Access Compliance Report

Public Rights-of-Way

(Curb Ramps)

Intersection ID: 30048	Main Street: ABLE_GLEN_CT	Cross Street: MORNING_CREEK_LN	Location:	N
ADA ID: 3E83241AA009	Ramp Type: PerpDiag	Initial Pass/Fail: Fail	Overall Compliance: No	Severity Score: 22.5
Codes/Mitigation Info/Possible Solution		Field Measurements/Component Compliance

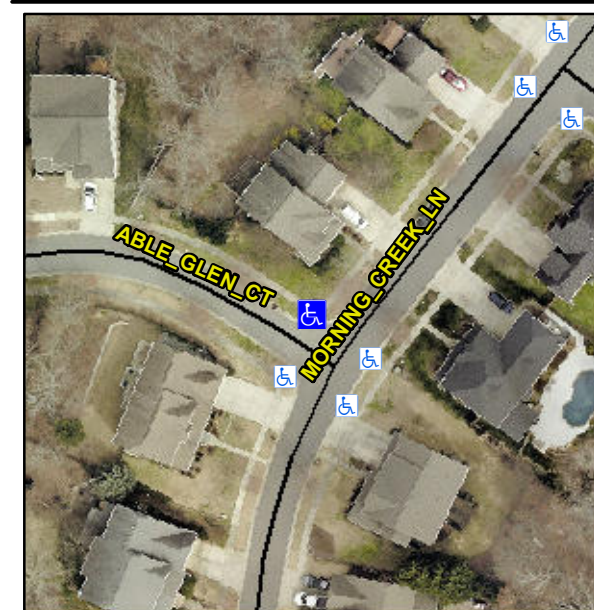
Not Found, R304.5.1, R304.2.2, R304.5.3

Compliance	Description	Data	Compliance	Description	Data
N/A	Ramp Length (in)	73.5	No	Ramp Slope (%)	10.0
No	Ramp Width (in)	41.0	No	Ramp XSlope (%)	2.3
N/A	Flare Type LT	N/A	N/A	Flare Type RT	N/A
N/A	Flare Slope LT (%)	N/A	N/A	Flare Slope RT (%)	N/A
N/A	Flare Traversable LT?	N/A	N/A	Flare Traversable RT?	N/A
N/A	Landing Length (in)	N/A	N/A	DWS Provided?	N/A
N/A	Landing Width (in)	N/A	N/A	DWS Contrast?	N/A
N/A	Landing Slope (%)	N/A	N/A	DWS Length (in)	N/A
N/A	Landing X Slope (%)	N/A	N/A	DWS Full Width?	N/A
N/A	Landing Curb? (Y/N)	N/A	N/A	DWS Offset (in)	N/A
N/A	Shared Landing?	N/A			
N/A	Gutter Ponding?	N/A	N/A	Gutter Slope (%)	N/A
N/A	Gutter Lip Ht (in)	N/A	N/A	Gutter X Slope (%)	N/A
N/A	Painted X Walk1?	No	N/A	Painted X Walk2?	No
	X Walk 1 Direction	To SW		X Walk 2 Direction	To SE
N/A	X Walk 1 Width (in)	N/A	N/A	X Walk 2 Width (in)	N/A
	X Walk 1 Slope (%)	5.8		X Walk 2 Slope (%)	1.8
	X Walk 1 X Slope (%)	1.1		X Walk 2 X Slope (%)	4.4

Remove & Replace Curb Ramp With Two New Directional Ramps or Equivalent.
